Agenda
City of Springboro Planning Commission Meeting
Wednesday, July 12, 2023, 6:00 p.m.
Council Chambers, City Building, 320 West Central Avenue

Background Information & Staff Comments/Recommendations
City of Springboro Planning Commission Meeting
Wednesday, July 12, 2023, 6:00 p.m.
Council Chambers, City Building, 320 West Central Avenue

A. Final Approval
Site Plan, 3233 South Tech Boulevard, new commercial building for Innomark

B. Final Approval
Site Plan Review, 25 West Central Avenue (SR 73), new River Valley Credit Union branch

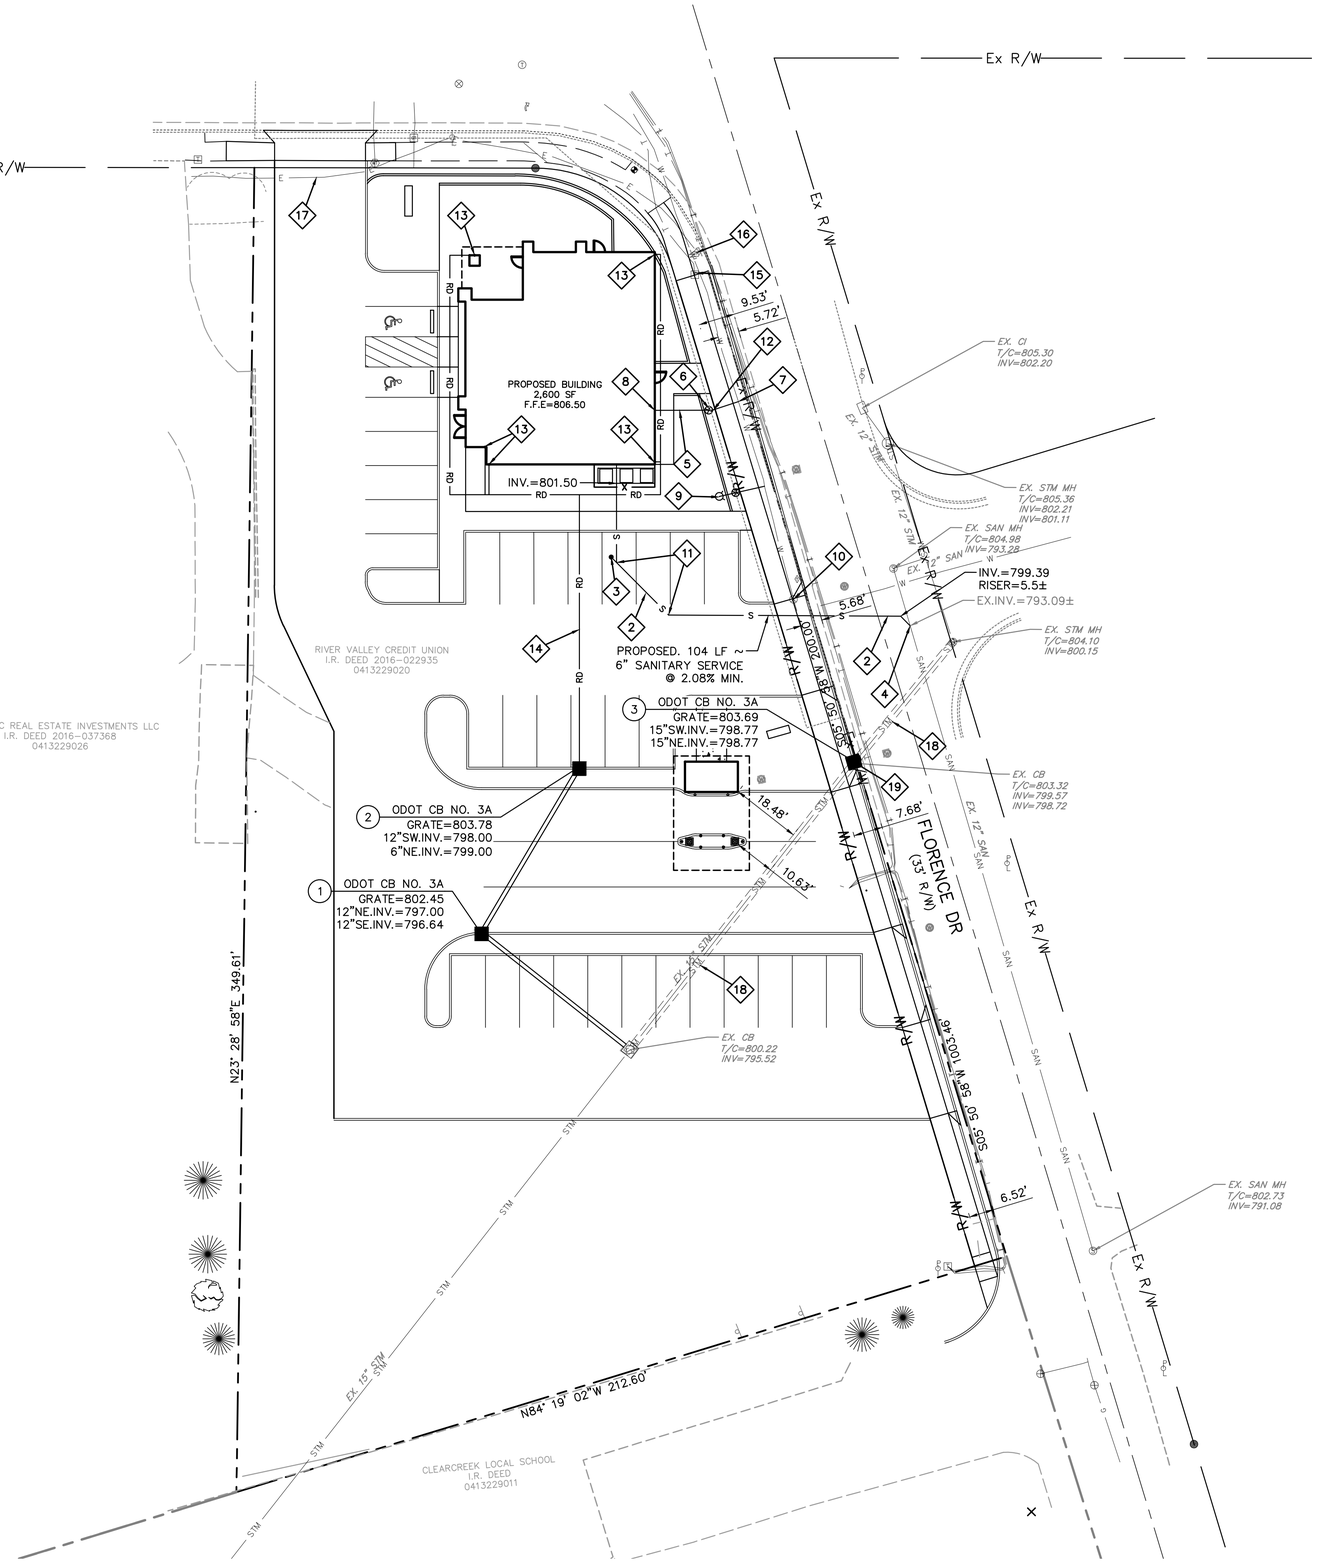
4. Provide record plan dedicating the additional right of way.
5. Sheet C400 – Utility Keynote 5 – Water Service lateral to be "K" copper material; revise accordingly. Revise Keynote 7 to be a direct tap to existing water main, and not a tapping sleeve. Add info for keynote 4. Utility plan note 2 – water line cover to be minimum 54". Remove utility note #10 to state water main shall be class 52 ductile iron.

6. Remove curb and gutter on SR 73 accordingly and replace with ODOT Type 2 depressed curb and gutter. Add details on plan.
7. Sanitary sewer lateral to be tapped straight into existing main with sweeping wye, and remove riser in street. Add cleanouts in the sewer lateral in the parking lot at all bends. Lateral to be SDR 35 or SCH 40 material (utility note 8 – sheet C400).
